NUMBER: 84-20

- A. MerCruiser I and TR Models Making a Whining Noise
- B. New Transmission Shift Lever on MerCruiser 370TRS/400TRS

Figure 1. Propeller Modification

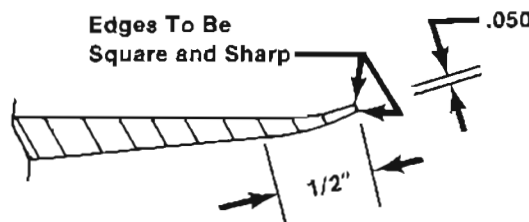
If you encounter a MerCruiser I or TR model that makes a whining (singing) noise between 800 and 1200 RPM in forward gear, problem may be caused by the propeller blades having too thick of a trailing edge. To the best of our knowledge, only Black Max and TR propellers are subject to this problem. In most cases, the whining condition can be eliminated by performing the modification outlined following.

1. Thin trailing edge of blades to 0.050" (1.3mm), by removing material from side opposite the cup (low pressure side). Blend into original thickness approximately 1/2" (13mm) forward of trailing edge. Thin each blade from root to center of tip.
2. Remove any roughness on cup side of blades.
3. After thinning blades, file trailing edges so that edges are square and sharp.

Figure 2. Transmission Shift Levers

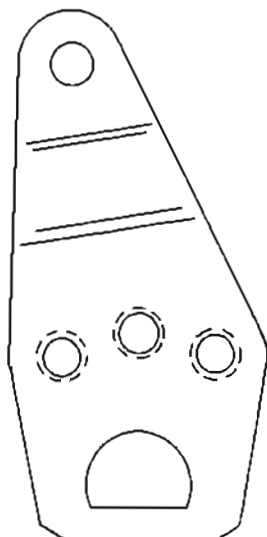
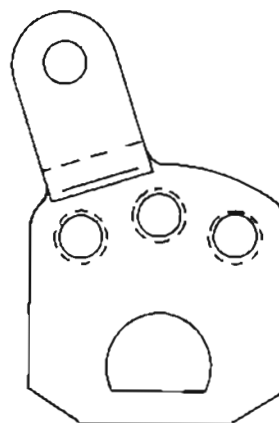
A new transmission shift lever 12128 is now being used on 370TRS and 400TRS models. (Figure 2) Starting serial numbers for engines with the new lever are shown following:

The new shift lever enables any of the Quicksilver Remote Controls to be used with these engines. With the old lever, only the Quicksilver Two-Lever Remote Control could be used. Remote control binding would occur if a single-lever control was used.

Figure 3. New Shift Lever Installation

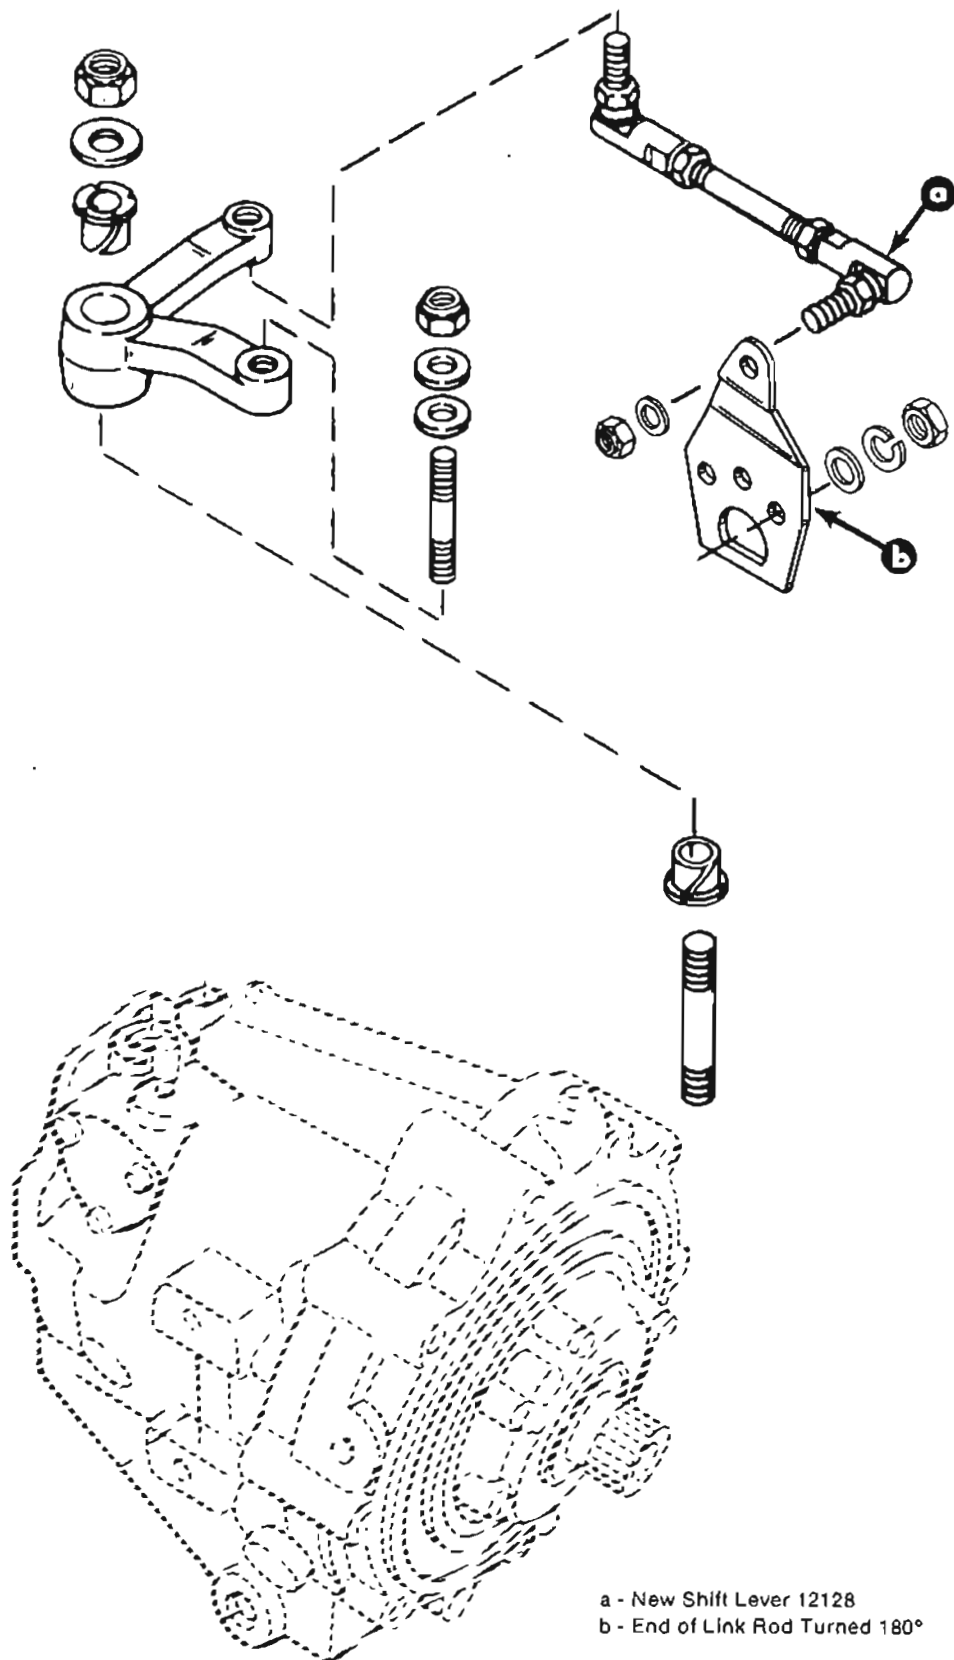
New shift lever can be used on older engines. End of link rod must be turned 180° to allow connection to new lever. (Figure 3)
